**SERVICE BULLETIN**

**SB05-8A**

**SUBJECT: IMPROVED CAMSHAFT GEAR P/N 656818**

**PURPOSE:** To announce the production of an improved camshaft gear P/N 656818 which supersedes the current camshaft gear P/N 656031

FIGURE 1  
UN-MODIFIED PERMOLD CRANKCASE

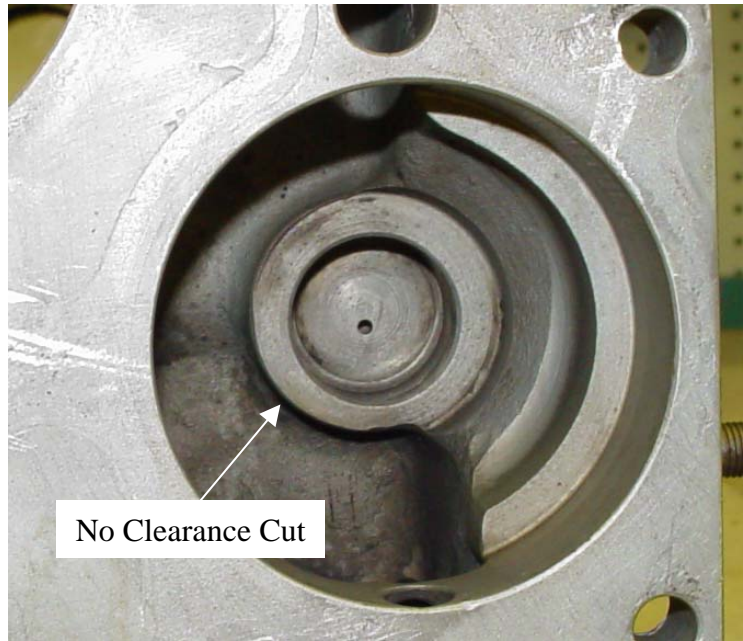
The P/N 656818 camshaft gear is nominally 0.060" wider than the P/N 656031 camshaft gear. On engine models utilizing the Sandcast style crankcase, the P/N 656818 camshaft gear may be installed as a direct replacement for the P/N 656031 camshaft gear. On engine models utilizing the Permold style crankcase, modification of the starter adapter shaftgear bearing boss is required to provide clearance for the wider camshaft gear.

**CAUTION...** Installation of the new P/N 656818 gear in an unmodified permold style crankcase will result in damage to the gear and/or the crankcase

**FIGURE 3  
PERMOLD CRANKCASE MODIFICATION**

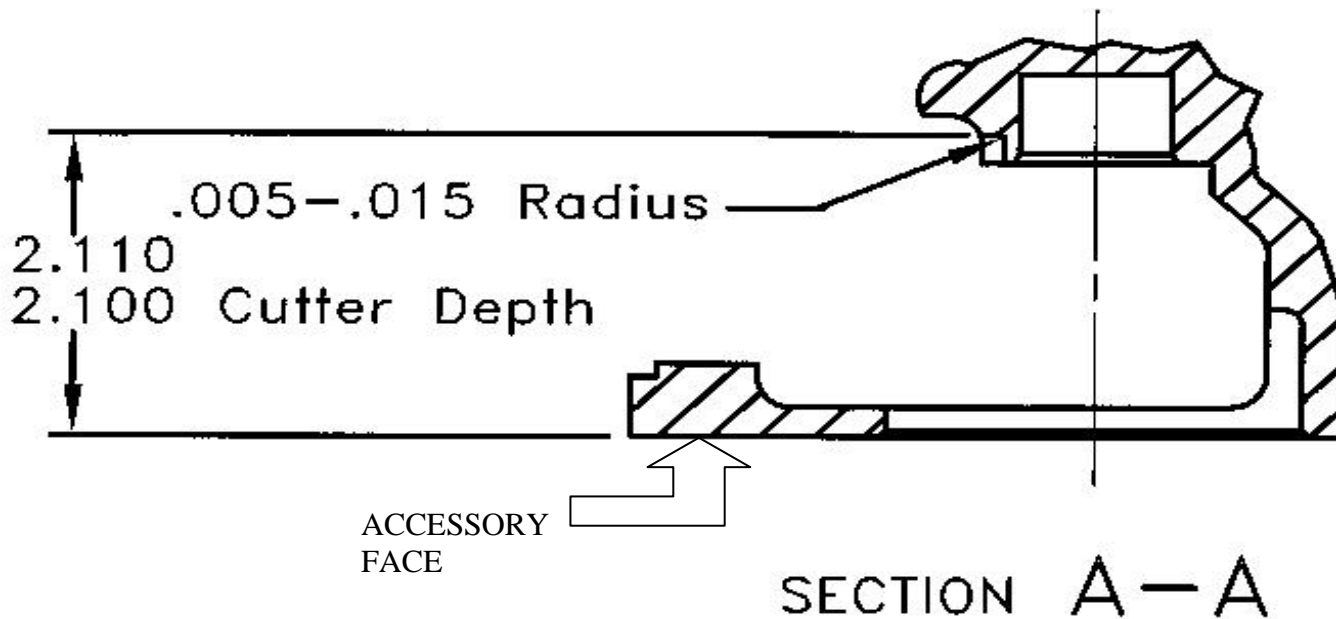
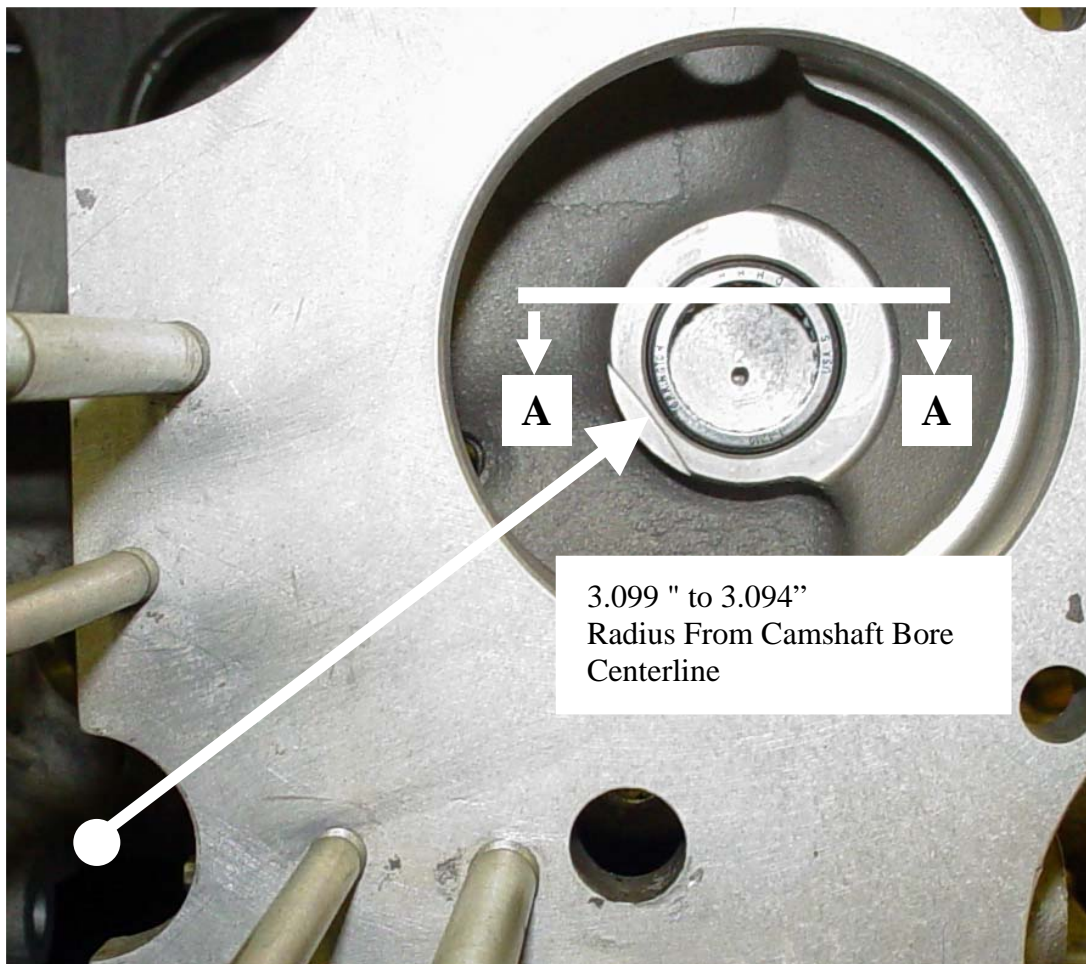
The Permold style of crankcase must be modified to allow use of the new, thicker camshaft gear. A clearance cut is made in the starter drive bearing boss in accordance with the dimensions shown in Figure 3. TCM recommends that a properly certified repair station machine the required clearance.

**FIGURE 4**  
**INSTALL CAMSHAFT IN CRANKCASE HALF**  
**INSPECT FOR MINIMUM OF .030 CLEARANCE BETWEEN THE CAMSHAFT**  
**GEAR AND THE END OF THE OIL GALLERY PLUG (WHERE INDICATED).**

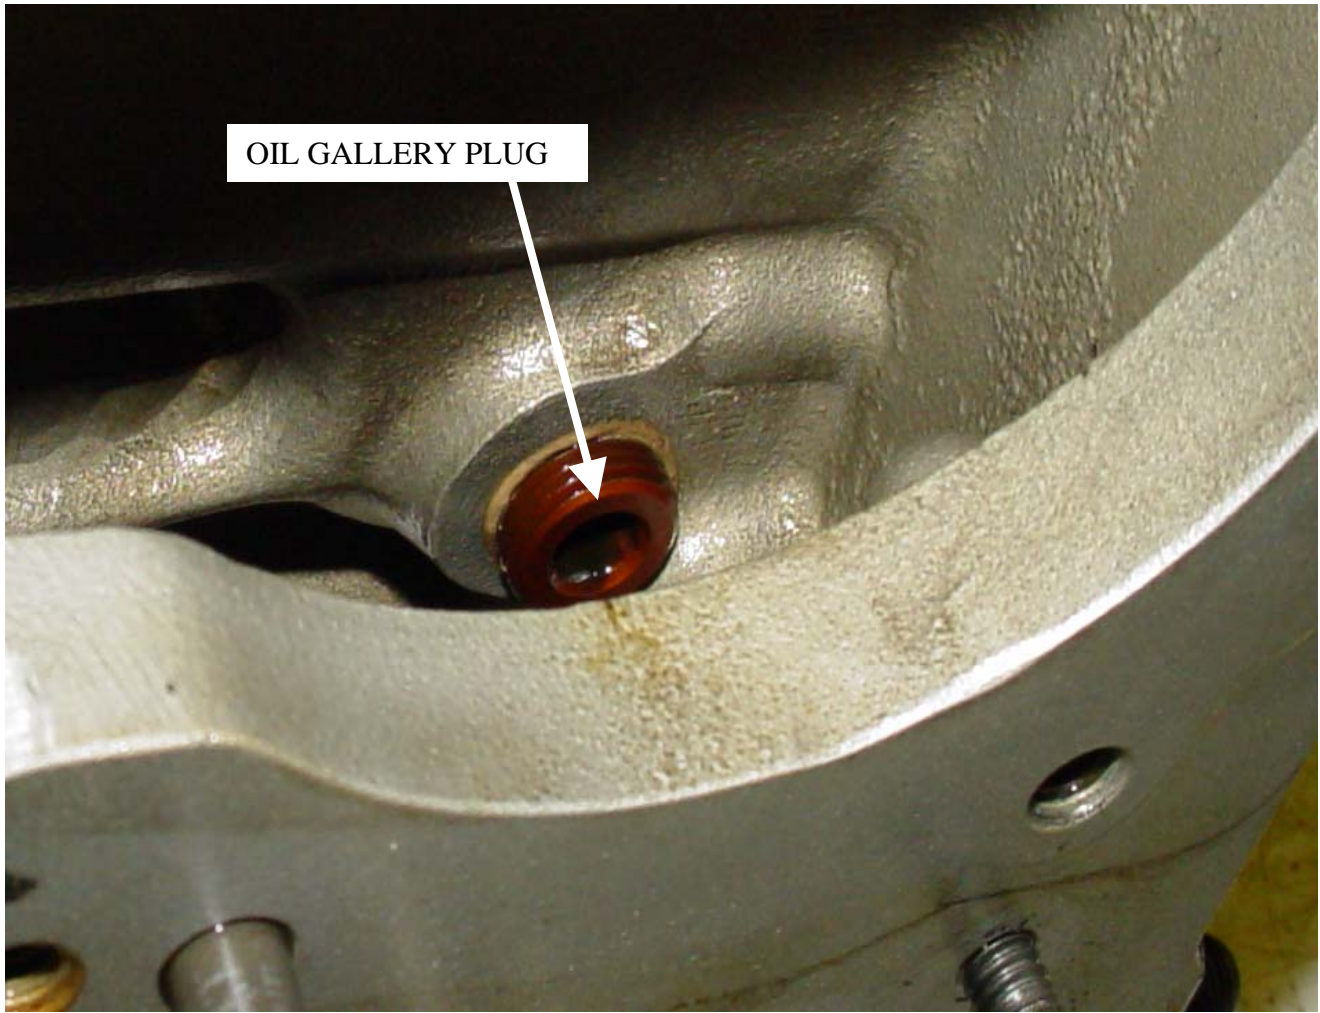
**NOTE...** On Sandcast crankcase installations clearance must be verified between the new P/N 656818 camshaft gear and the oil gallery plug located directly below the starter adapter boss. (Reference figure 4.)
